PLAN COMMISSION SPECIAL MEETING

A. Review of Site and Architectural Plan for the construction of a Taco Bell restaurant at 1803 Washington Street, submitted by Pacific Bells (applicant) and CEHOG I LLC (owner); Recommendation to City Council (Tabled from January 13, 2025 Meeting)

Project: Taco Bell 1803 Washington Street Two Rivers, WI

Re: Design Committee Review Comments Pacific Bells LLC - Taco Bell at 1803 Washington Street

CIVIL SITE PLAN

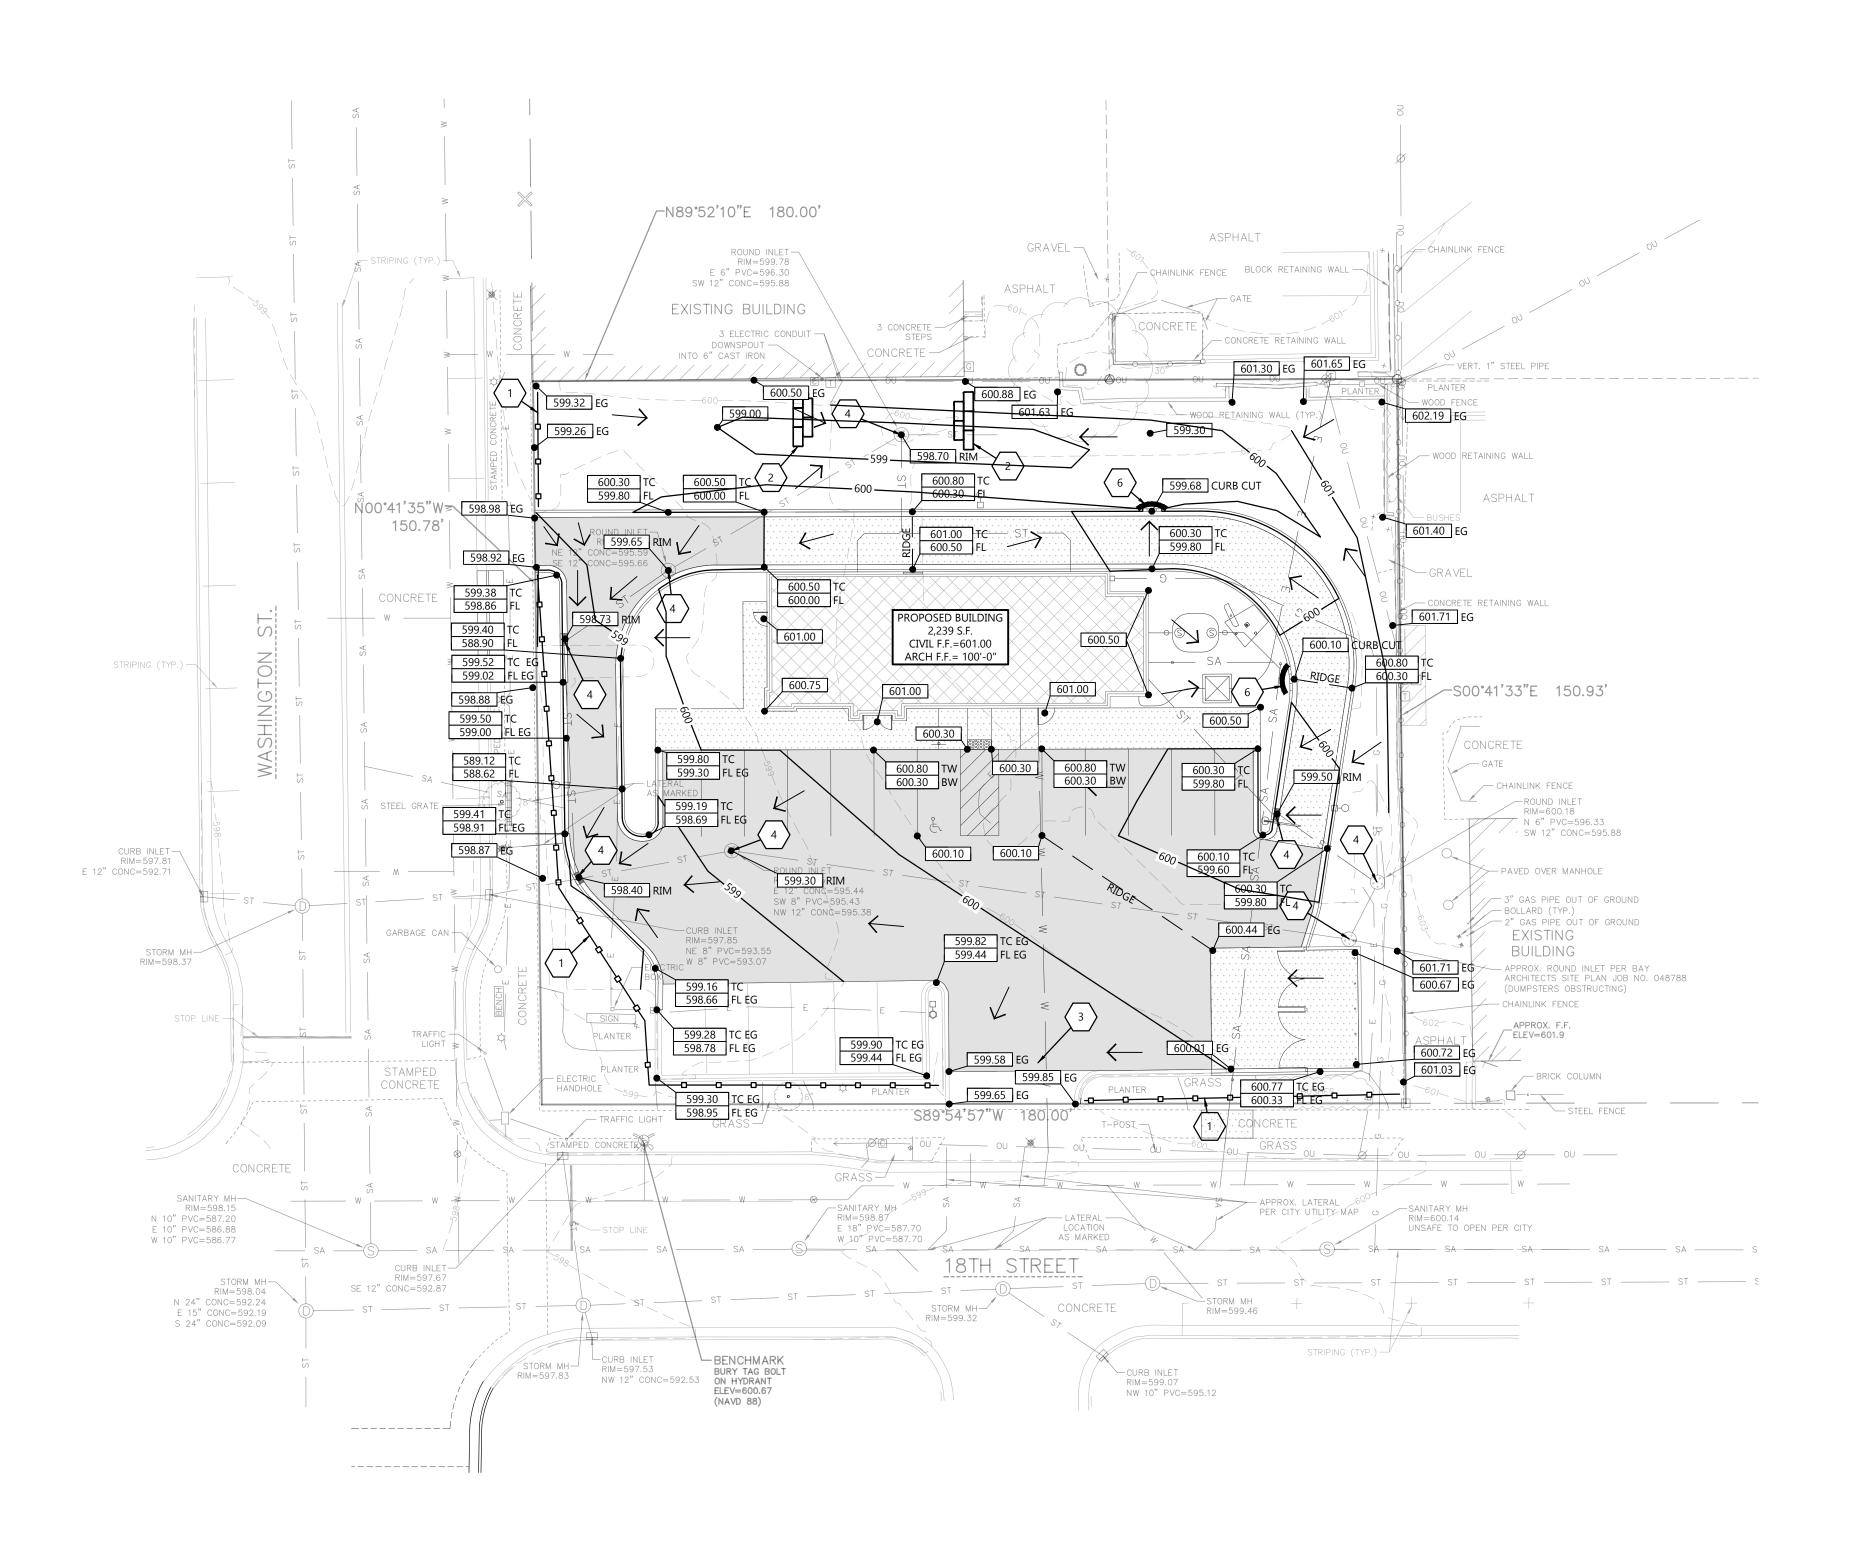
- Committee members expressed concerns regarding the proposed structure blocking the recently installed mural, but noted that the mural would provide a pleasant view for drive through customers. Is there another design that could be substituted? Could the location of the building be shifted or placed on a diagonal?
 Excel Response: Shifted the building 10' east to allow the mural to be seen by a stopped northbound car at the intersection of Washington Street and 18th street. See vision triangle on C1.1.

- 2) The committee appreciates the plan to retain and rebrand the existing monument sign. Excel Response: Noted.
- The committee has concerns regarding the impact traffic exiting onto Washington Street may have on the goal of creating a pedestrian friendly downtown.
 Excel Response: Noted. Existing driveway width decreased and driveway revised to exit only.

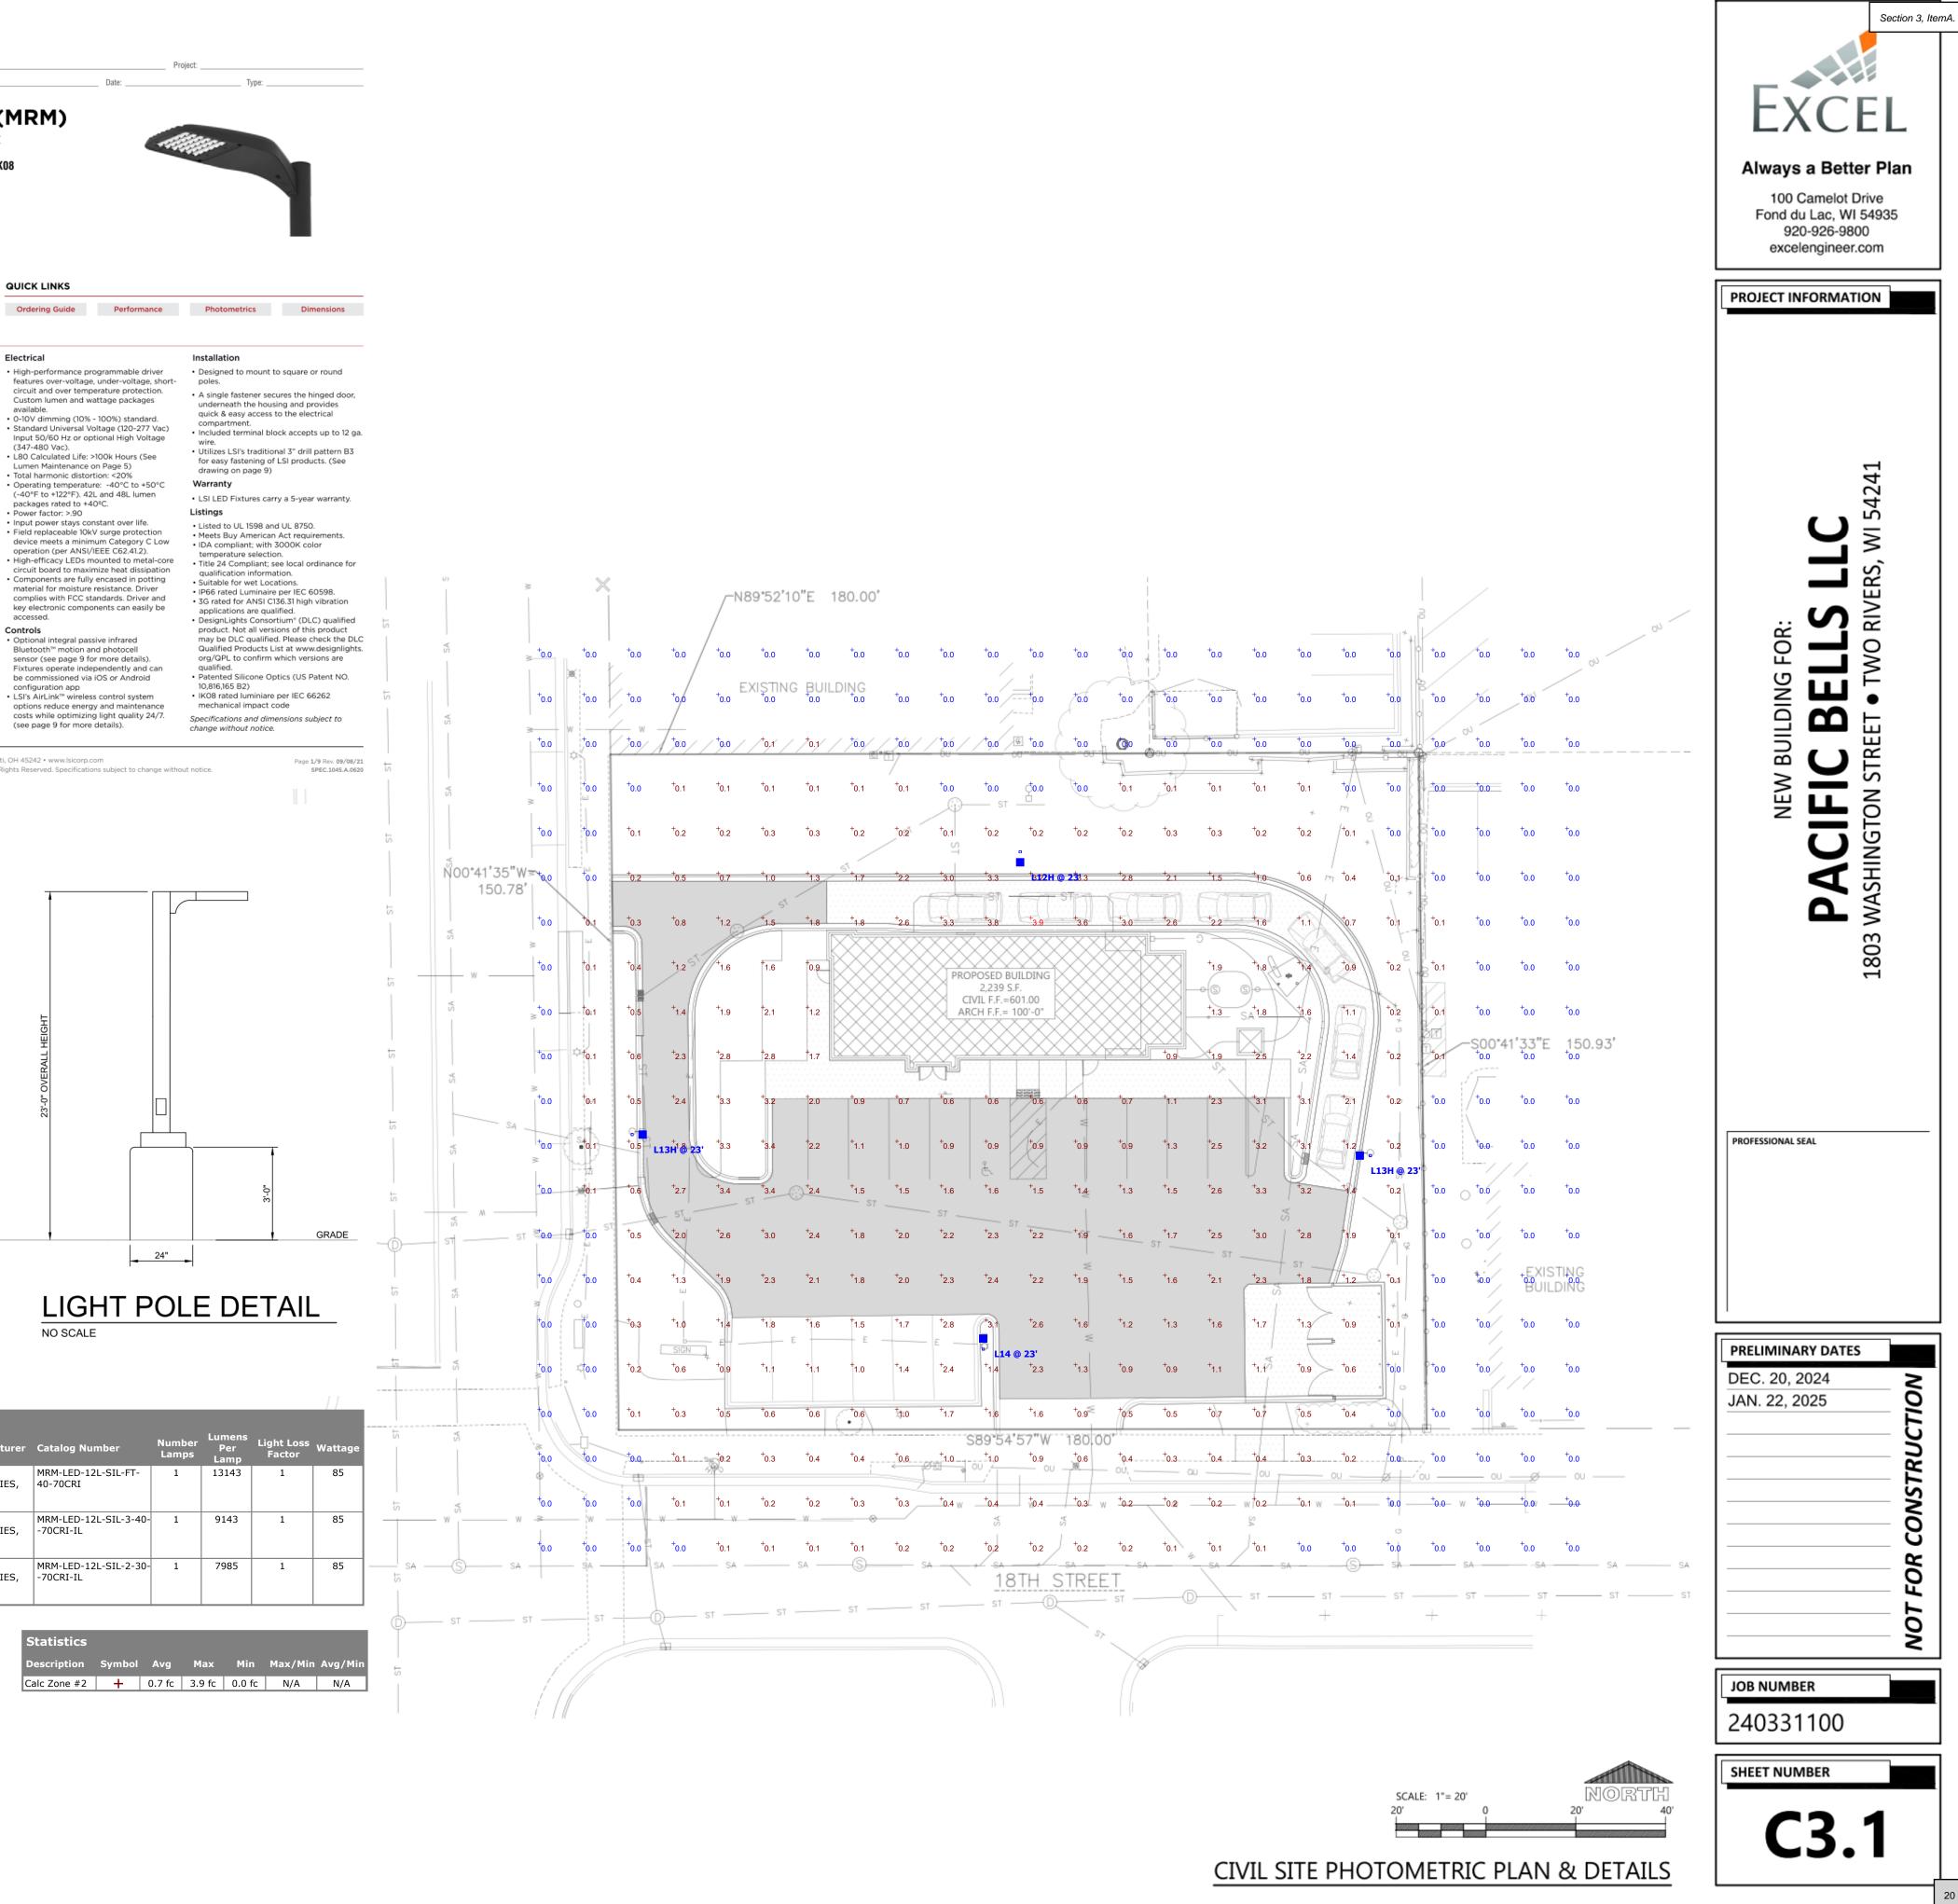
- 4) The committee had some concern regarding the height of the proposed light poles as they relate to existing light poles on Washington Street, but appreciates that they are IDA compliant.
 Event Because The bright of the poles are shown on the site photometric plan (C2-1) at 22

Excel Response: The height of the poles are shown on the site photometric plan (C3.1) at 23'.
